Annexure 3

**Explanation of recommended
amendments to the exhibited version of
the building envelope controls**

Amendments following practitioner workshops

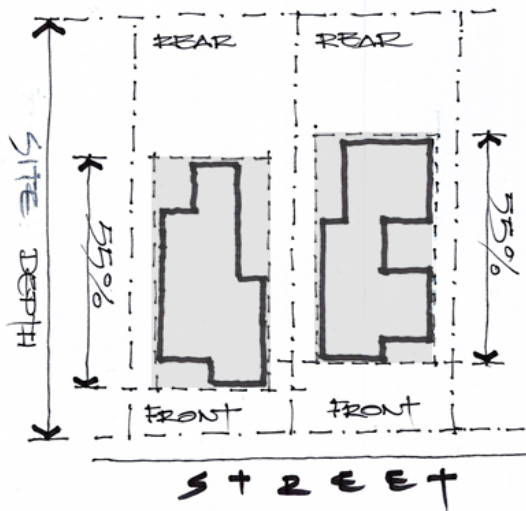
The rear setback in the exhibited controls was determined by calculating 25% of the site depth (i.e. length of the site). However, depending on the front setback and shape of the site, this control produces varying building footprints and therefore development yields.

We recommend replacing this with a control that provides a more consistent development yield across sites.

The amended control establishes the rear setback based on the front setback, site depth and building depth. This produces a development yield that is relative to the size of the site.

- B3.2.4 Rear setback: Insert new control at C1 identifying that the rear setback is a consequence of the site depth, front setback and building depth.
- B3.2.4 Figure 6 (as renumbered): Amend diagram to illustrate how the rear setback is measured.

By relating the depth of the building footprint to the depth of the site, the building footprint is proportional to the size of the site. The building depth is obtained from the building depth sliding scale (explained below). Generally, the building footprint depth is 55% of the depth of the site. This building depth must be located behind the front setback.
